TO: Members of the MAG Standard Specifications and Details Committee

SUBJECT: MEETING NOTIFICATION AND TRANSMITTAL OF TENTATIVE AGENDA

MAG Standard Specifications and Details Committee
TENTATIVE AGENDA
May 4, 2016

MEETING MINUTES FROM THE
MARICOPA ASSOCIATION OF GOVERNMENTS
STANDARD SPECIFICATIONS AND DETAILS COMMITTEE

DETAIL NO.
236-1

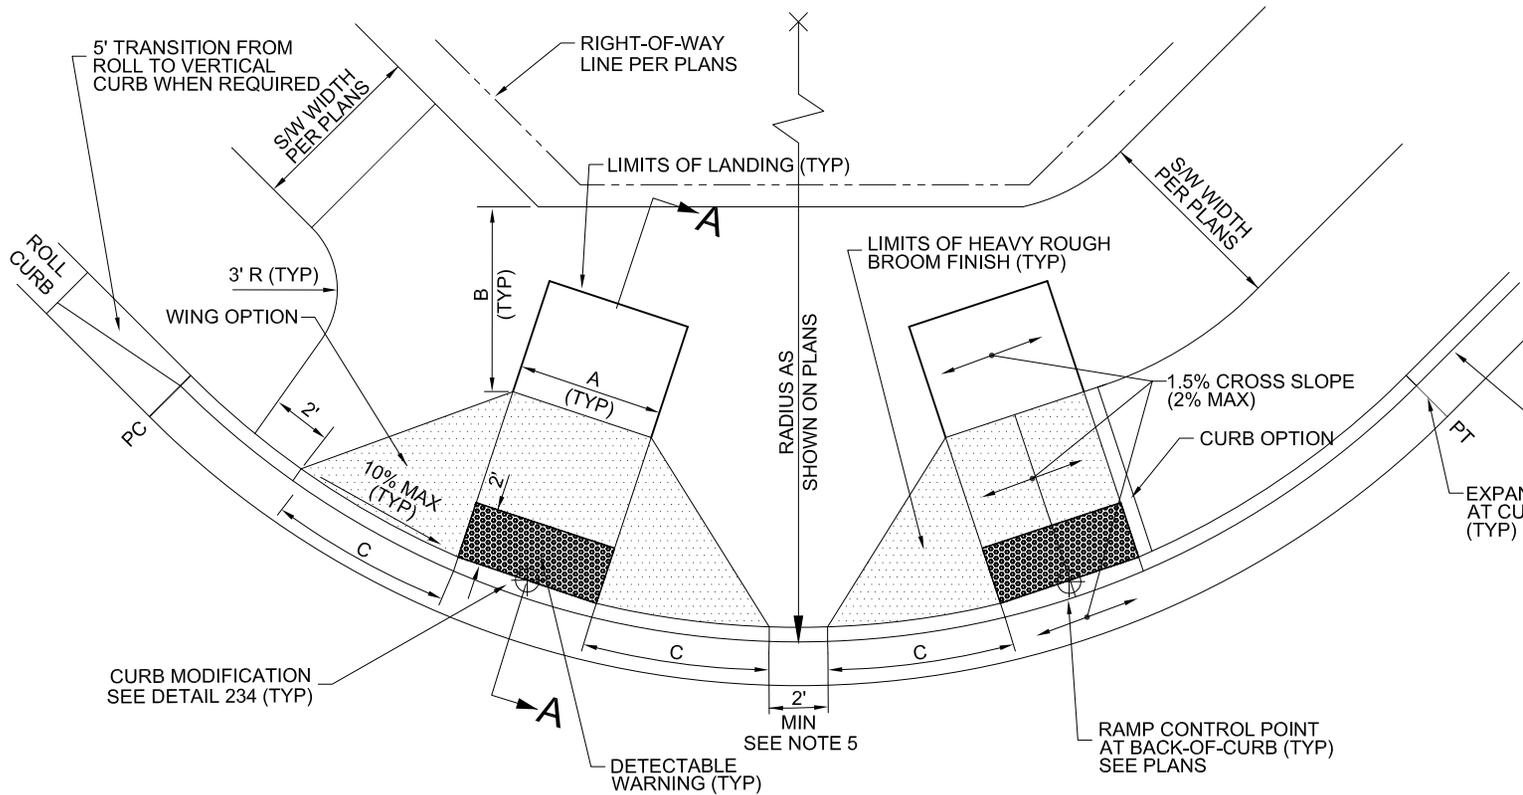
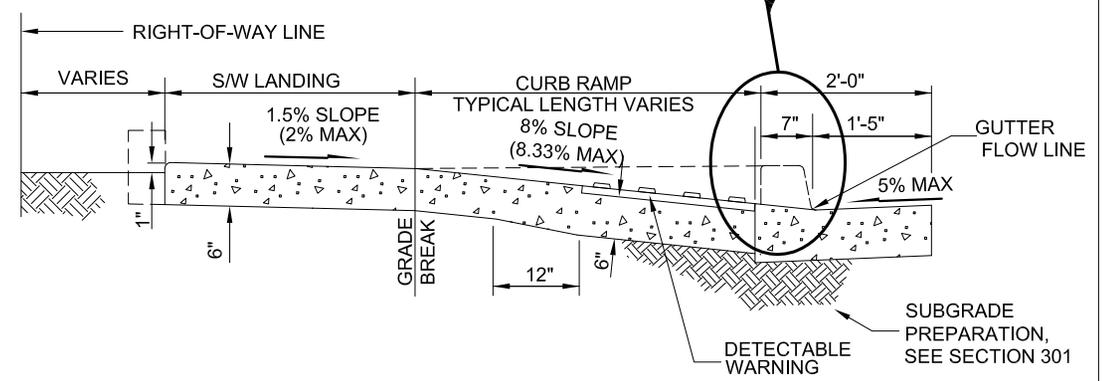
Detail 236-1 added a note for concrete thickness to be 6" at arterials and 4" at locals. There was a good discussion on the preferred thickness of the concrete. Jim Badowich said he would prefer 9". Roy Herrington said Scottsdale had a problem with 4" thick wings being broken when trucks drove over them, and now Scottsdale requires thicker ramps and wings. Craig Sharp said it is a problem, and landscaping company trucks often drive over the ramps. He would like the thickness to be 9" for arterials and 6" for local streets. Mr. Badowich agreed even though the ramps are not intended for traffic. Roy Herrington had questions about payment limits on transitions from 6" to 4" thickness, but Craig Sharp said in the current specs it is not measured as a separate pay item. Rob Godwin said he has seen signs that warned of fines for driving on the sidewalks, but Jim Badowich said he would prefer to be proactive rather than reactive.

Mr. Godwin also suggested having specs on making repairs. Tom Wilhite proposed adding construction joints so that if one ramp is damaged both don't have to be rebuilt. He gave an example in Tempe of potholing that went through a ramp when locating utilities on a project, requiring it to be rebuilt. Warren White said Chandler had a detail that he could share. Mr. Wilhite also noticed that Detail 236-2 was missing the A-A Section cutting plane line, and also thought it would be more consistent to choose using fractions or decimals, but not both as done in the section view. (Example: 1 1/2% and 8.33%) Mr. White understood the point and agreed 1.5% would be more consistent.

DETAIL NO.
236-2

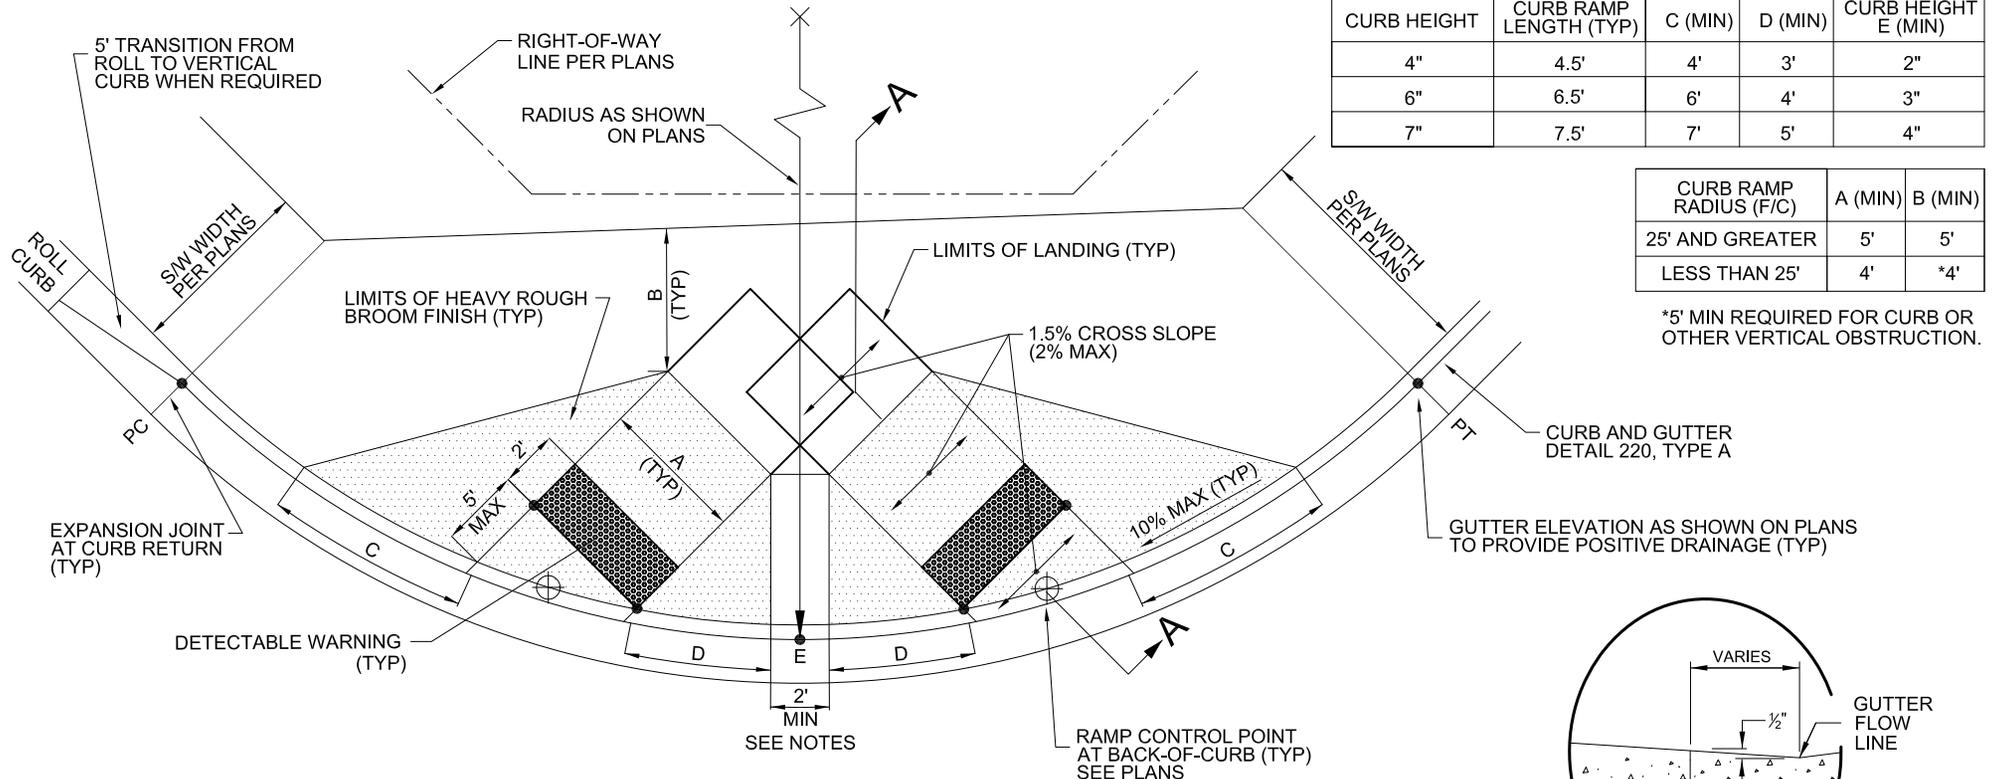
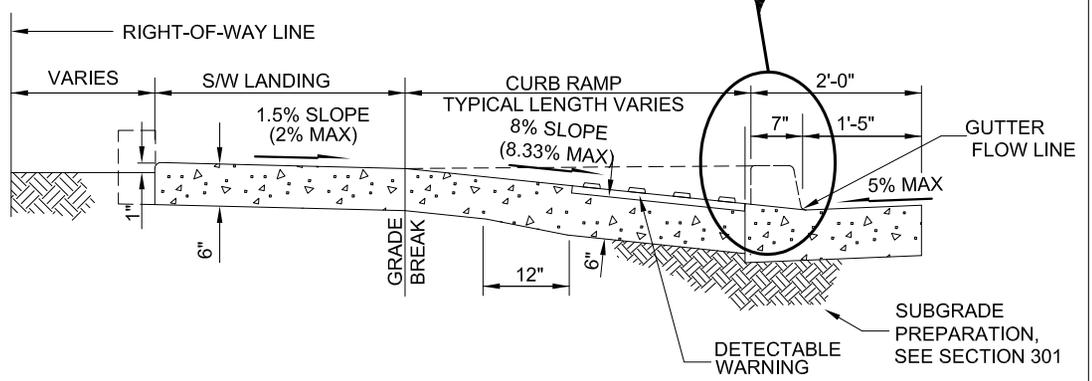
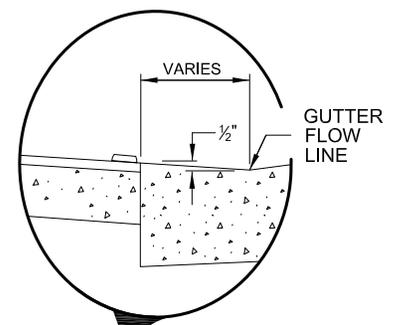
Tom Brennan asked about the use of the curb option rather than a wing on Detail 236-2. He was concerned that it may create a tripping hazard that could lead to litigation. Warren White said this curb type ramp was allowed under the proposed standards, but agreed it could be an issue. He noted it also caused the sidewalk to constrict even more on Detail 237-2.

DETAIL NO.
391-2

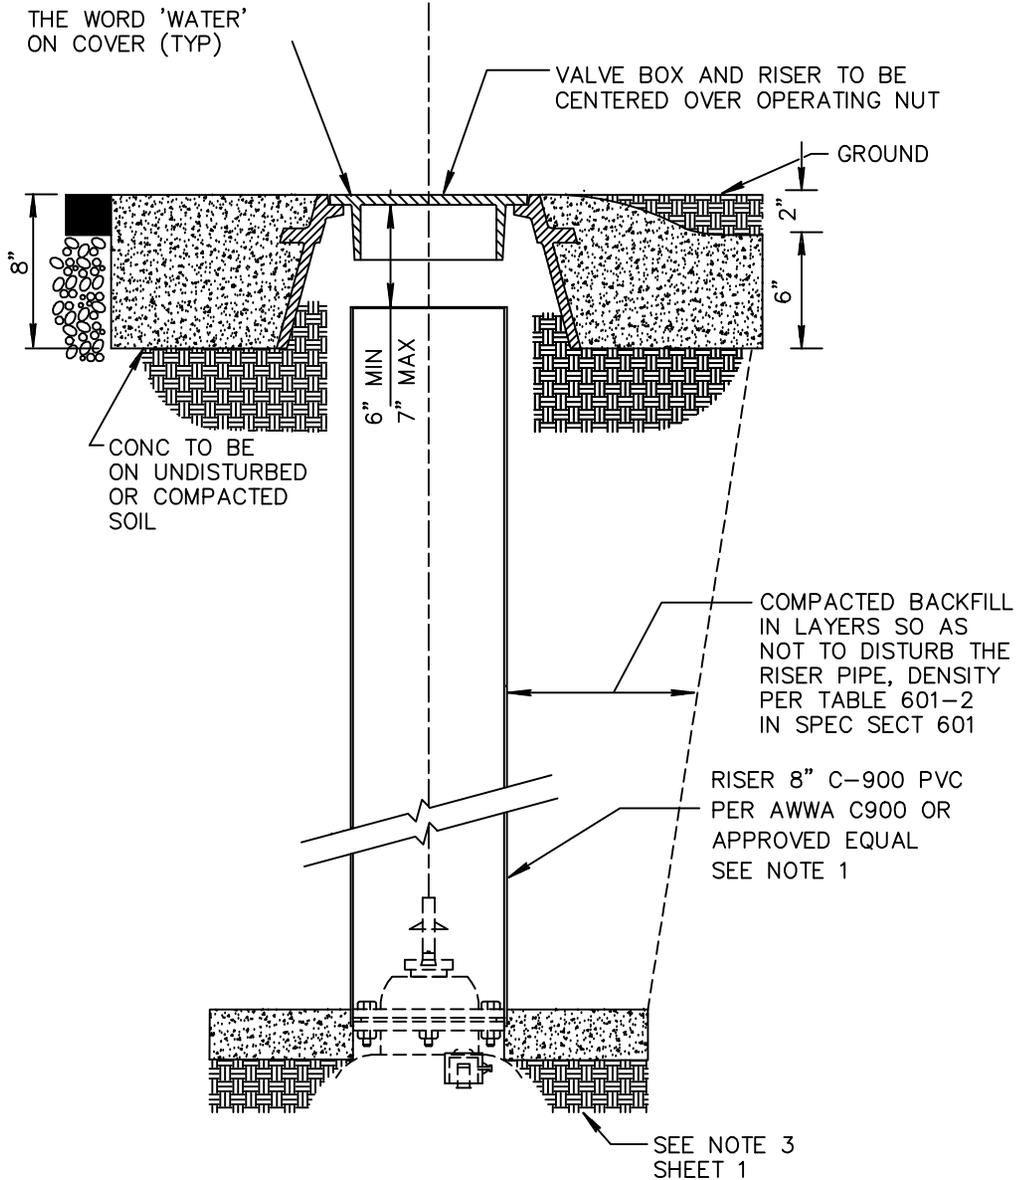
Craig Sharp said he is working on a case to modify the valve key in Detail 391-2.

Craig Sharp said he had a new case, and provided draft details that separated the Water Valve Extension (new Detail 392) from the current Detail 391-2 Valve Box Installation and Grade Adjustment. It also shows the sleeve for the valve stem extension. He plans to introduce this as a new case at the next committee meeting.

Revision to Detail 391-2 to remove Valve Stem extension drawing

Create new Detail 393 for the valve stem extension.
